TO: *mf* Marco Foster, MS473 54
THRU: *TRM* T. Madden / K. Klingman, NB82-230
FROM: *PF* P. Fuller / S. Beadle, NB 82-66
SUBJECT: C8 549
SR99, AWW Replacement North Access Connection
F.A. Project No: STPF-0099(122)
CHANGE ORDER 125
EN6, EN3A & EN3B Ductbank Changes

**WASHINGTON STATE
DEPARTMENT OF TRANSPORTATION
CHANGE ORDER**

CONTRACT NO: 008549 FEDERAL AID NO: STPF-0099(122)
 CONTRACT TITLE: SR 99, ALASKAN WAY VIADUCT - REPLACEMENT NORTH ACC
 CHANGE ORDER NO: 125 M-1, EN6, EN3A, EN3B DUCTBANK CHG

PLAN REF. NO.
UPR1
 SHEET
 219
 OF
 770
 SHEETS

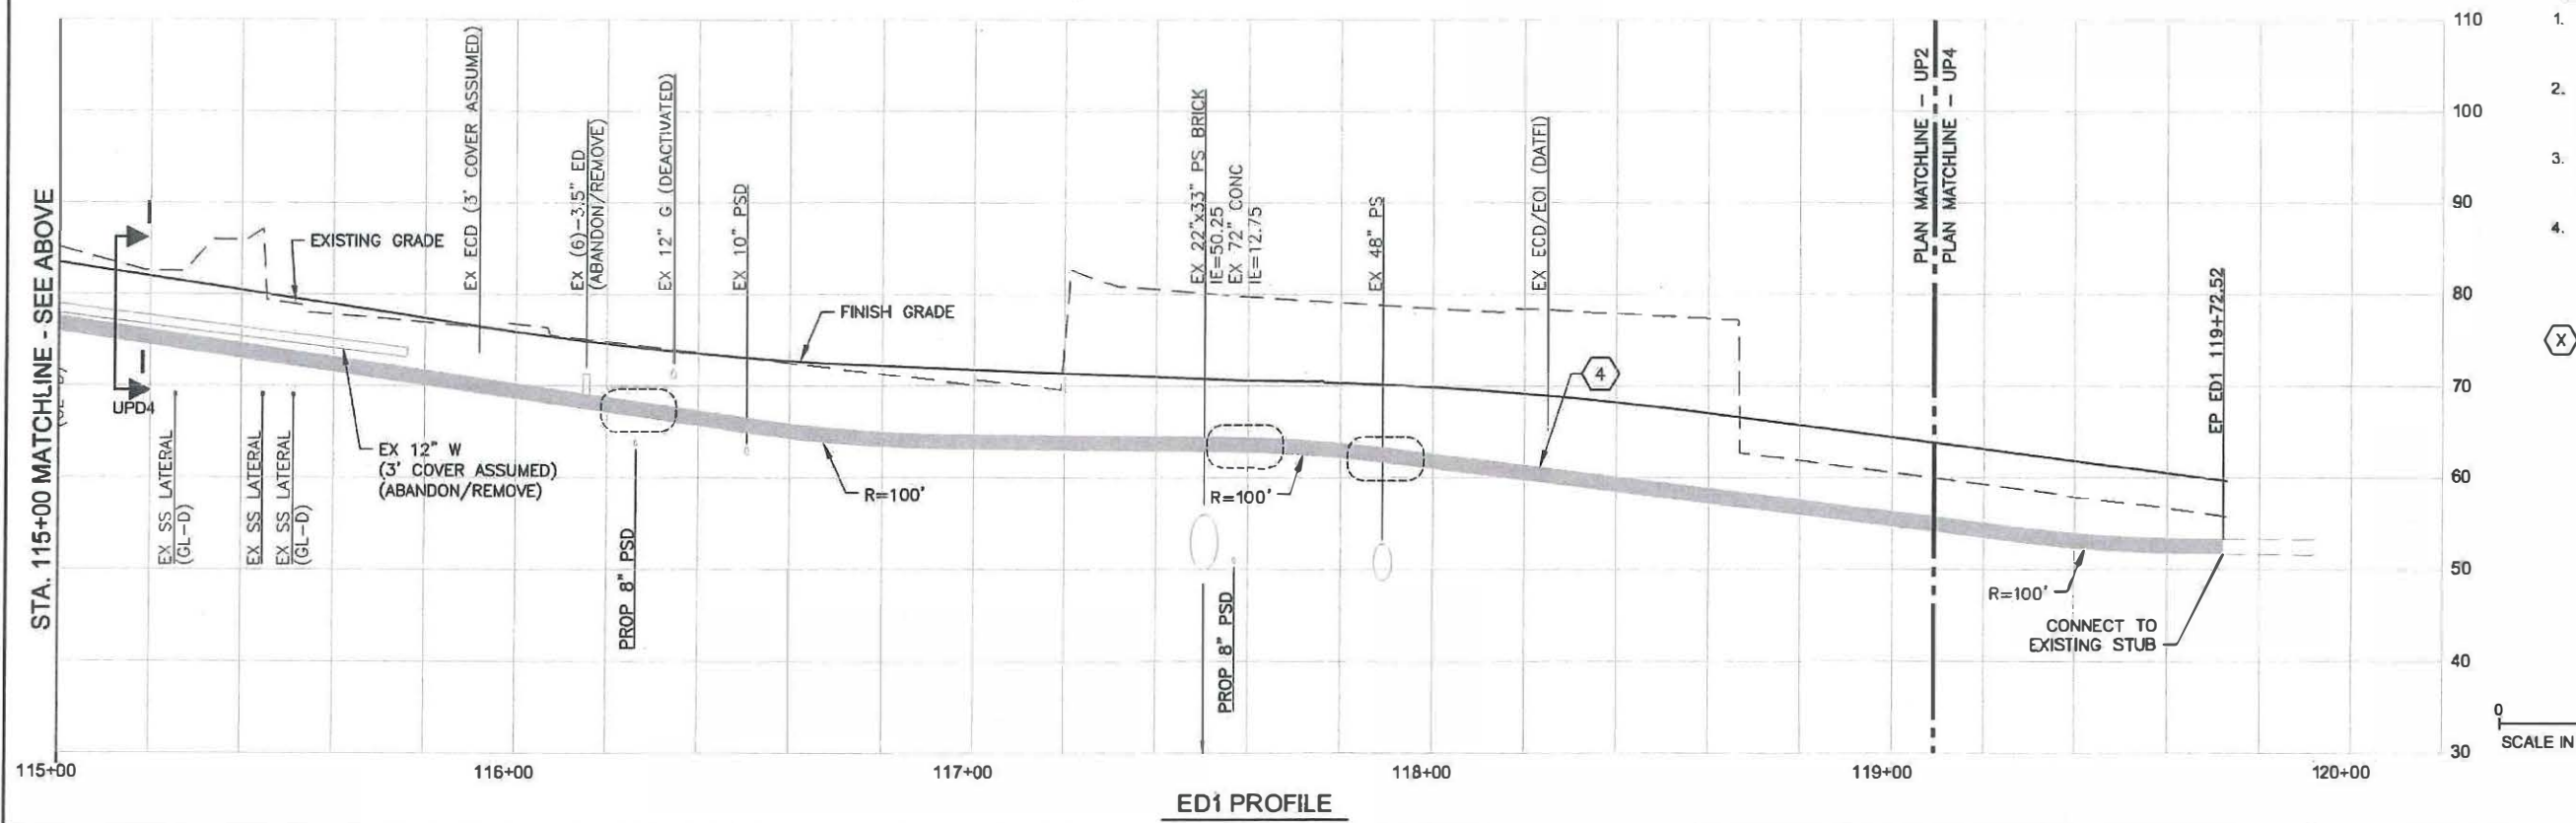
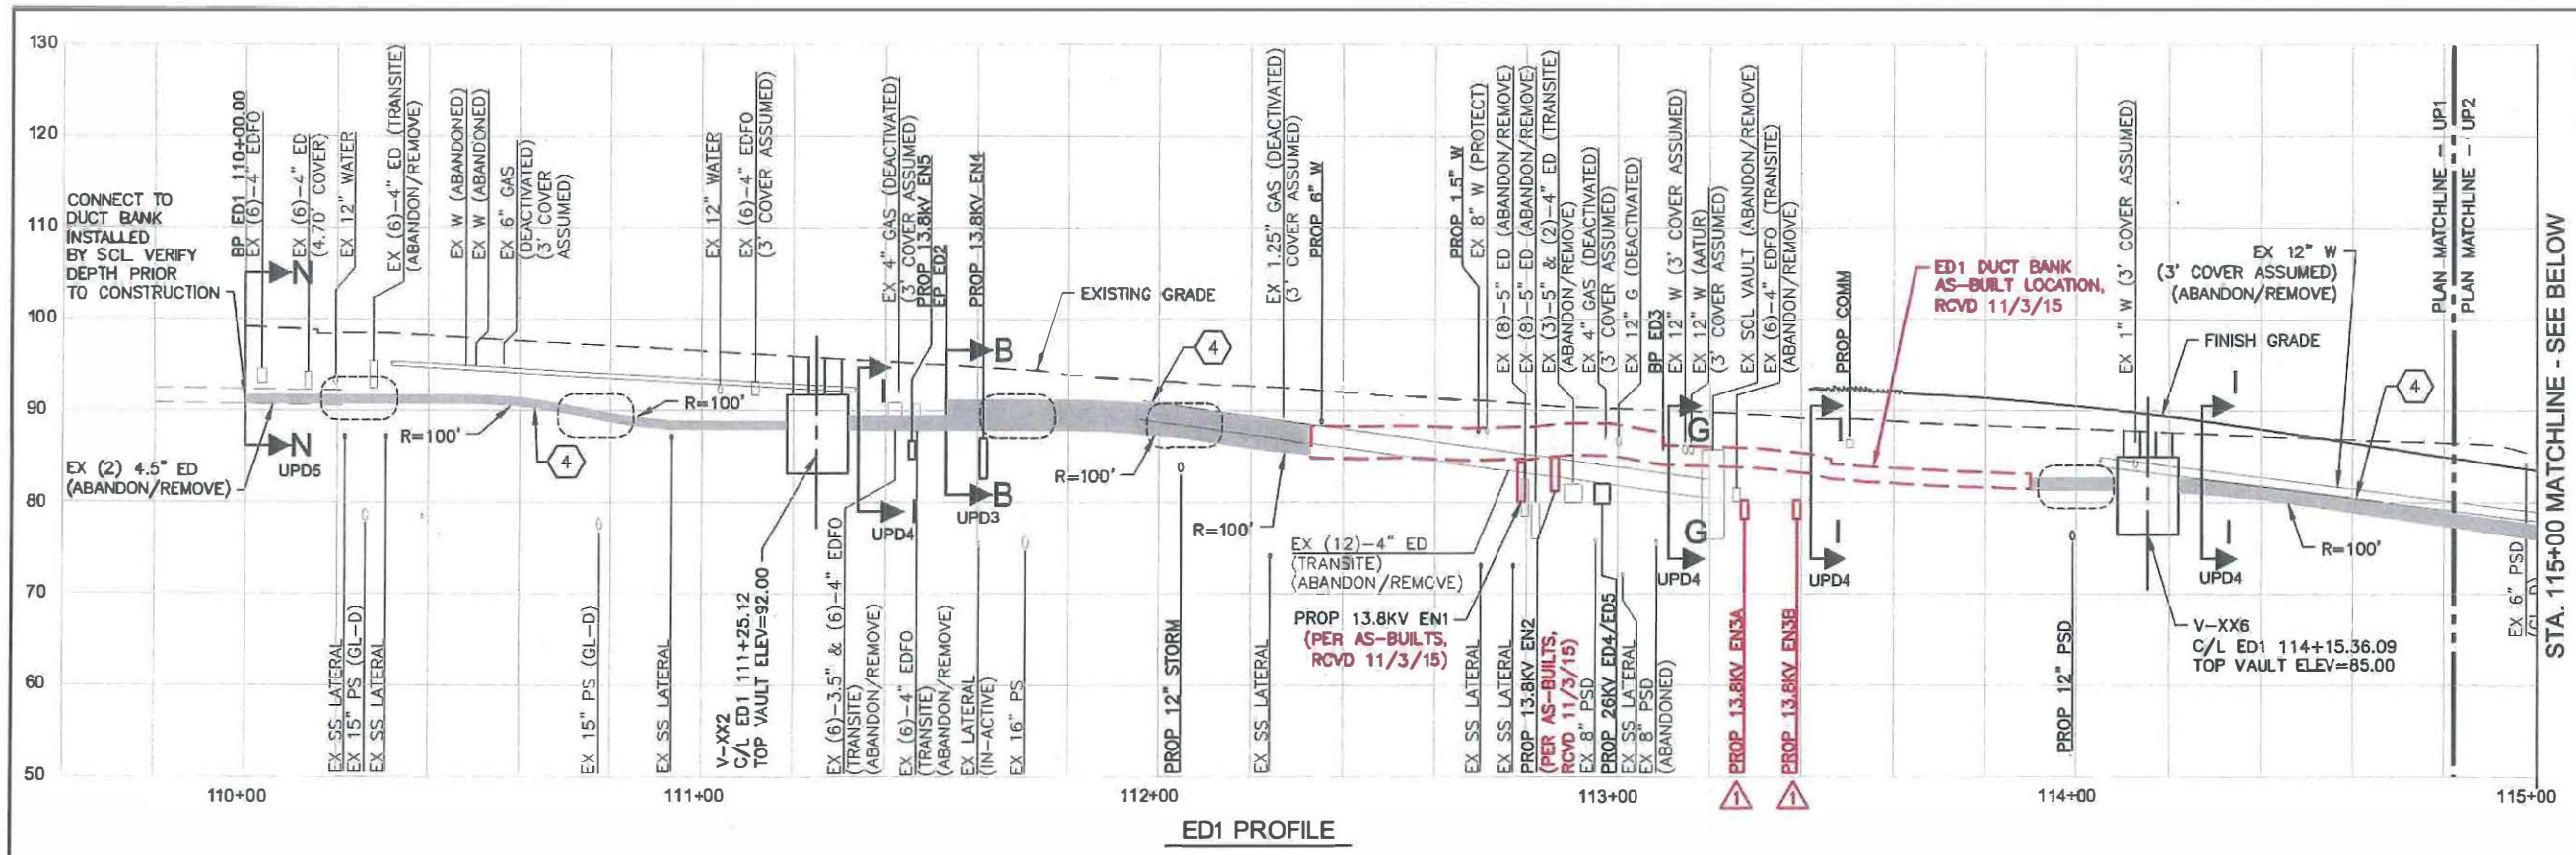
Adds new ductbank EN3A from station EN3A 238+00.00 to 238+50.03 and adds new ductbank EN3B from station EN3B 239+00.00 to 239+43.37 as shown on plan sheets UPAL1, UPT3, UP1, UP9, UP16, UPR1, UPR9, and UPD10. This work consists of excavation and shoring, procuring ductbank materials and installing them, placing high strength FTB, forming materials, setting forms and stripping, placing low strength FTB, dirt export and disposal, vactoring, dewatering the excavation area, supporting existing utilities and existing foundations, mobilization and demobilization of equipment, survey and cleanup.

PLAN REF. NO. UPR7
SHEET 225 OF 770 SHEETS

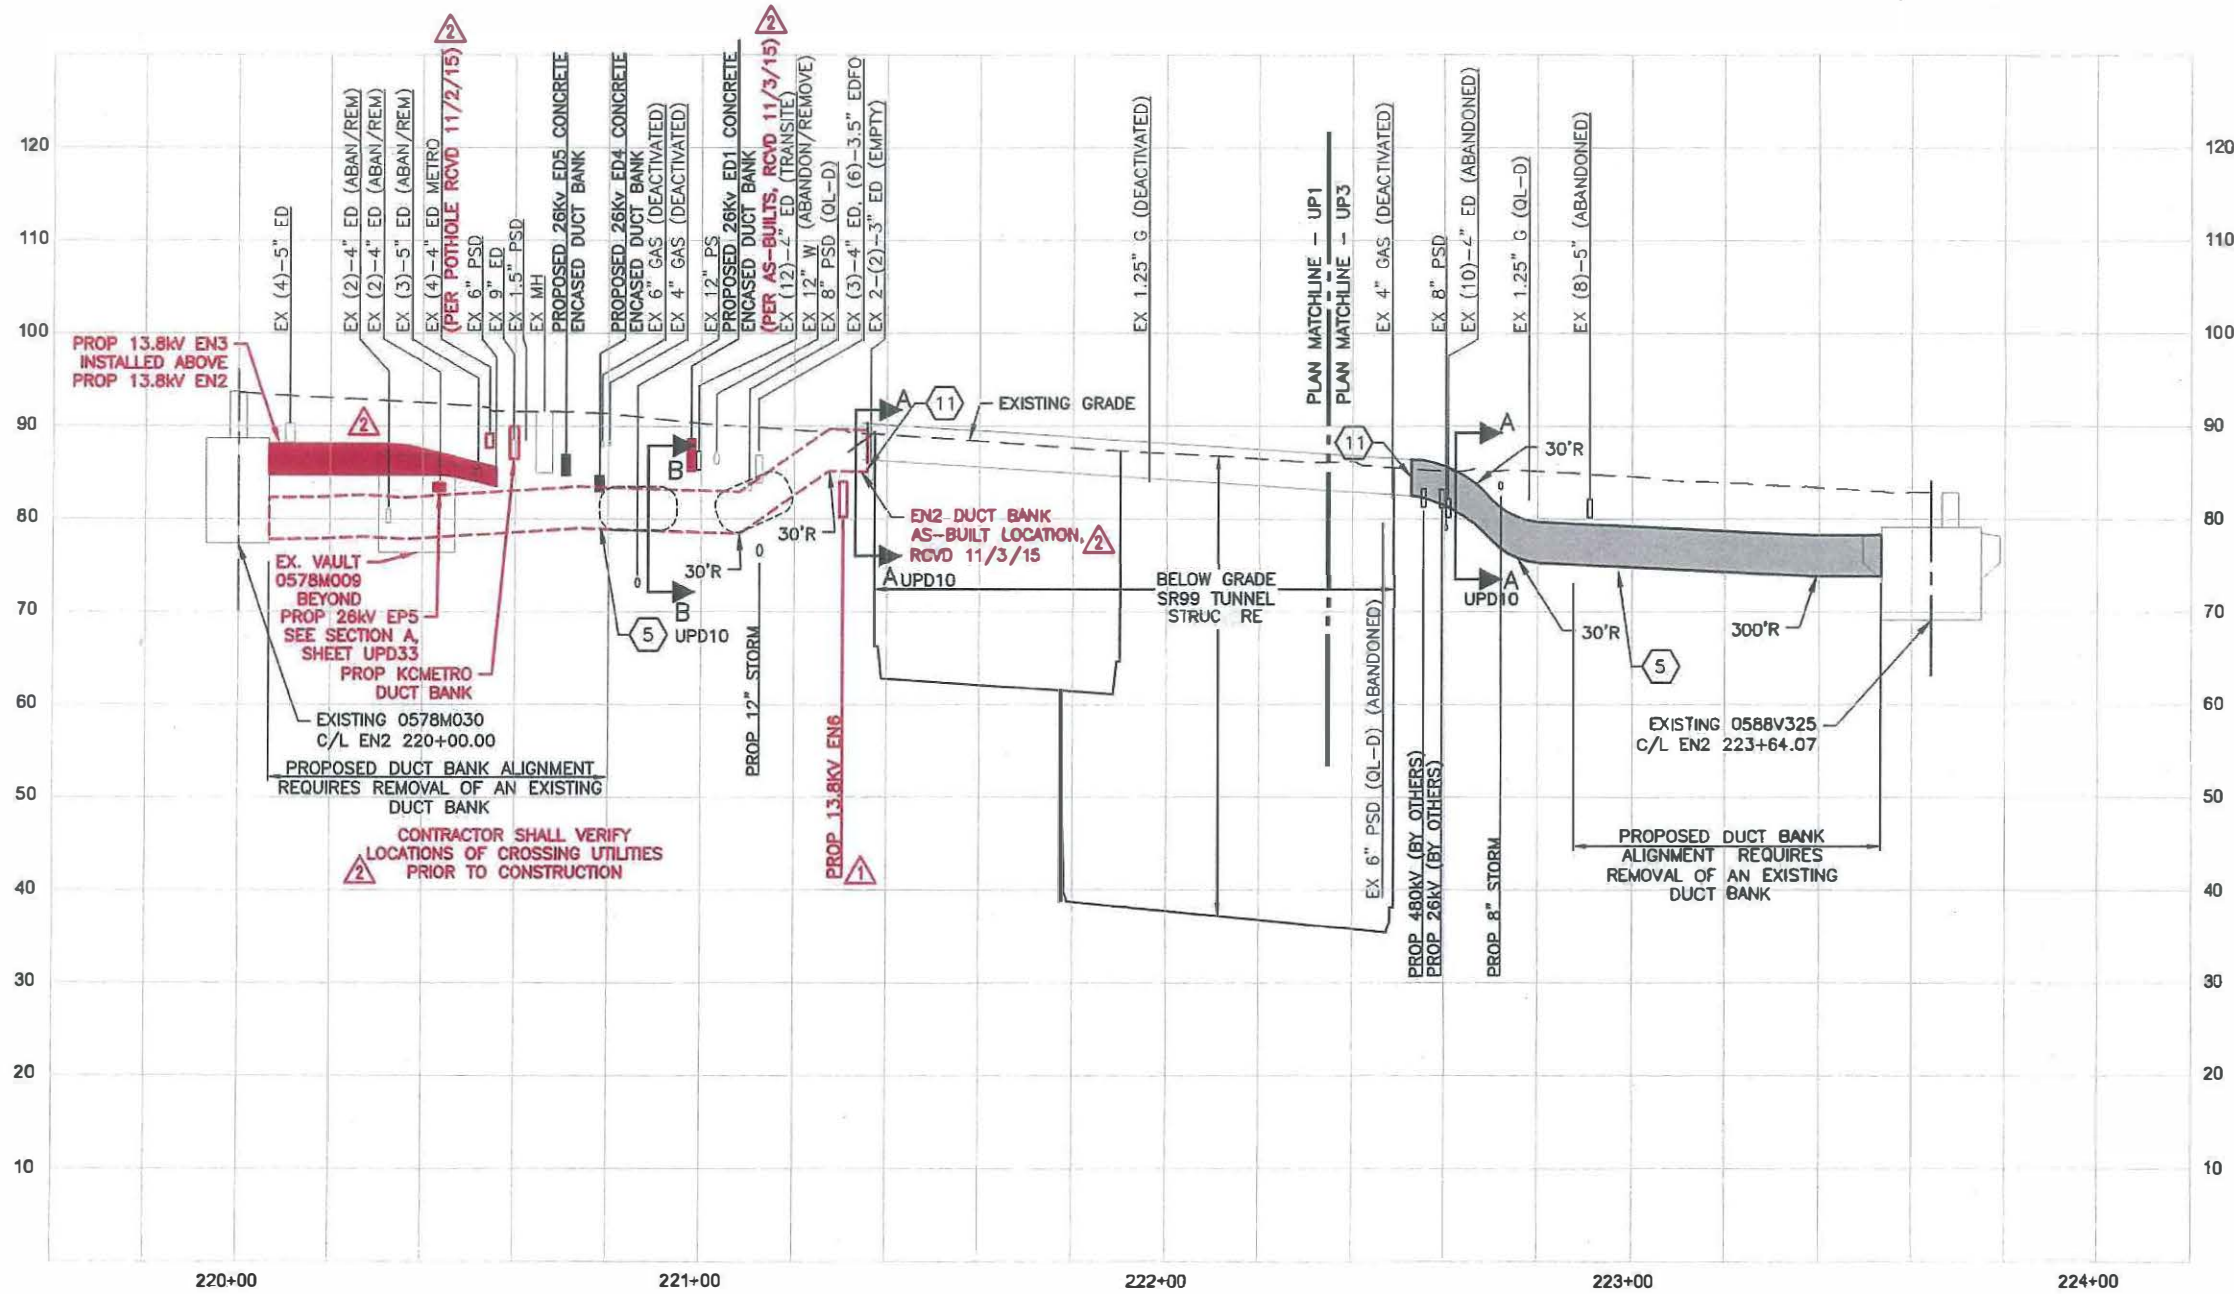
Adds new ductbank EN6 from station EN6 260+00.00 to 262+20.20 as shown on plans sheets UPAL1, UPT3, UP1, UP9, UP16, UPR2-UPR3, UPR7, UPR10A, UPD10, and UPD28. This work consists of excavation and shoring, procuring ductbank materials and installing them, placing high strength FTB, forming materials, setting forms and stripping, placing low strength FTB, chipping overpour at existing V-834, coring at V-834, dirt export and disposal, vactoring, dewatering the excavation area, 2ft overexcavation of trench and placing quarrying spalls and bedding, importing quarry spalls and bedding, supporting existing utilities which involves crossing live ductbanks at Harrison St. vicinity and supporting existing foundations, mobilization and demobilization of equipment, survey and cleanup.
